RE: Drop Yard NWA – Site Development Plan Variance Request
CEI Project No. 32987
SDP24-0571

Variance

PLANNING

NWA Drop Yard

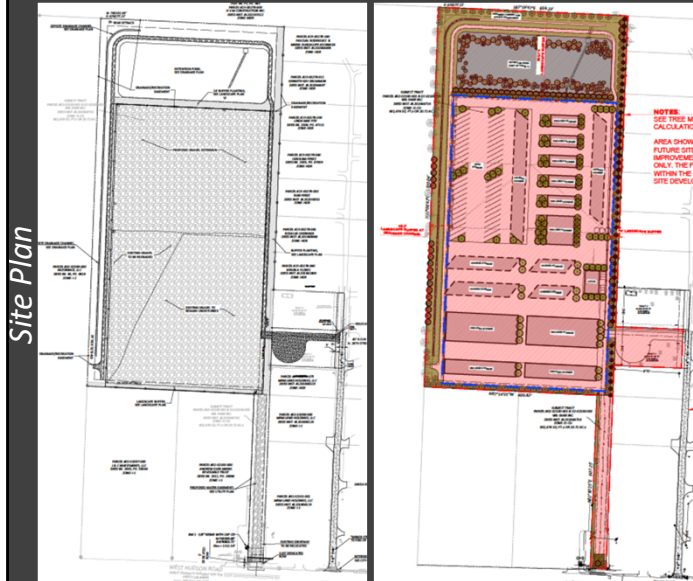
- The development proposal includes more than 13 acres of continuous gravel, to be used for vehicle and materials storage. The site currently contains about 8 acres of gravel, which is being used for storage.

- The UDC is silent on the use of gravel, given that it's not a permitted paving surface.
- Applicant is proposing to cover the majority of the site in gravel, to use for large equipment and vehicle storage.

No real hardship was stated for this variance, other than the full graveling is intended to be Phase 1 of the development, while Phase 2 includes full pavement and covered structures.

- There doesn't seem to be any site-specific hardship that would prevent the applicants from paving.
- The spirit and intent of the referenced code is not being met, because the referenced code doesn't pertain to this development at all – Section 5.3.3. regulates parking lot design and promotes pedestrian safety and comfort. The proposed development is industrial by nature and doesn't provide parking, or provide a use, that is inviting to the general public or pedestrians. The existing and proposed development features essentially zero pedestrian elements. More generally, the code doesn't list gravel as a permitted paving surface for development.
- The applicants could propose concrete pavement and eliminate the need for this variance.

DENY the request to allow gravel as a permitted paving surface for commercial developments.

Table 5.5.5.B Buffer Type Requirements

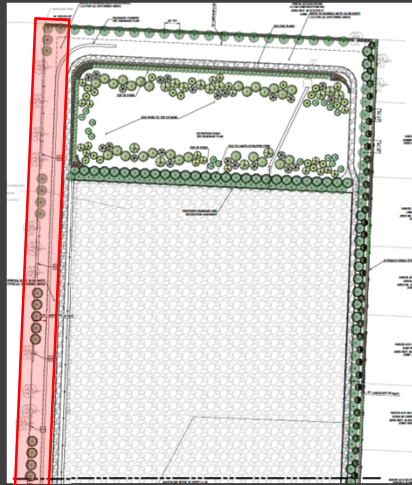
- Section 5.5.5. requires prescriptive landscaping screening for development proposals, depending on the zoning of the subject property and the zoning of the adjacent property.
- This request involves different request for the different directional property boundaries; west, north and east.

Variance Request Factors	
Does strict enforcement of the code cause undue hardship due to circumstances that are unique to this property?	Somewhat. Buffering on this side of the development isn't completely necessary, given the neighbor is an I-2-zoned fuel depot. The chart in the code that this requirement comes from needs amending.
How is the spirit and intent of the code being met?	Yes. They are proposing some new tree plantings on the west side to fill in the gaps in existing tree plantings.

- Strict enforcement of the code would require them to plant shrubs for an I-1 development against an I-2 existing development, that is used as a fuel depot. Screening shouldn't be required for this adjacency. Staff recommends amending this portion of the code to correctly reflect actual instances where landscape buffering is necessary.
- The spirit and intent of the code is being met, given that they are planting new trees along the west side to fill in gaps that existing trees do not fill.
- Shrubs could be planted here, but it wouldn't help buffering really at all, and it's not necessary.

APPROVE the request to modify the landscaping buffering requirements in Table 5.5.5.A along the western, northern and eastern property boundaries, with the following conditions:

Tree Fund Proposal

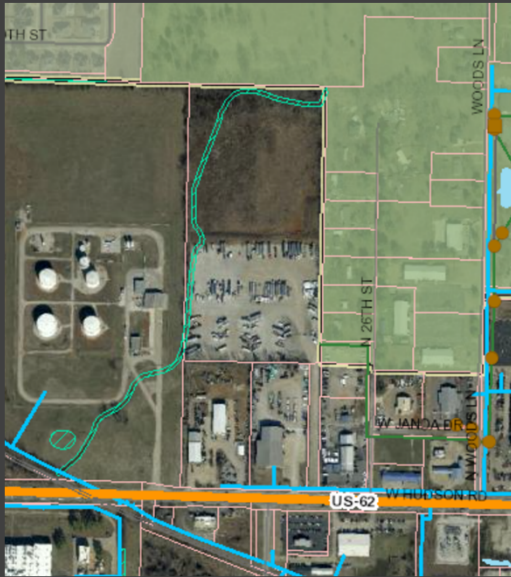
- In this instance, 514 Open Space trees are required and 356 trees are being provided by the applicant. That leaves a difference of 158 trees. Based on current landscaping prices, new trees are about \$200 per caliper inch. The UDC sets the standard for deciduous ornamental trees at a 2 caliper inch minimum. Based upon this formula, the applicants would be required to pay \$63,200 into the tree fund if they aren't willing to meet the landscaping code requirements.

Staff recommends a variance to Section 5.6.9. allowing the applicants to pay the difference in proposed plantings to required plantings as a monetary amount into the tree fund, regardless of the reason for which the planting requirement can't be met. Money in the tree fund would pay for tree plantings, installation and maintenance in underplanted or underserved parts of town.

158 trees x \$400(2" caliper tree x \$200 per caliper inch) = \$63,200

APPROVE a variance to Section 5.6.9., allowing the applicants to pay the difference for Open Space trees not provided into the tree fund.

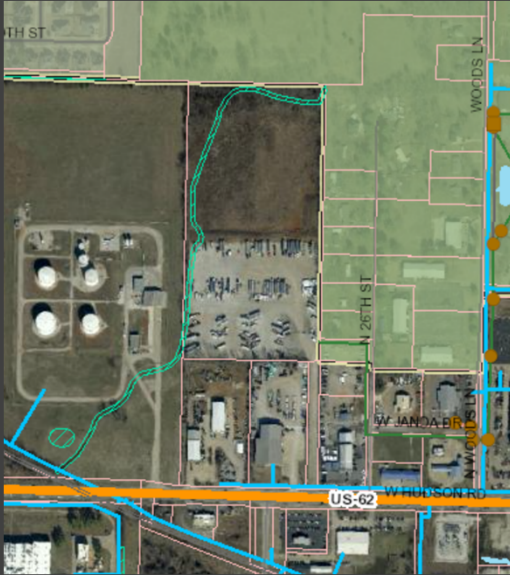
An opaque privacy fence, no shorter than 6’ tall, be provided east of the proposed landscape buffer along the eastern property boundary, that runs from the northeastern corner of the lot to the proposed entrance off of N. 26th Street.

DENY the request to allow less Open Space trees to be provided than what is required per Section 5.6.4.2.
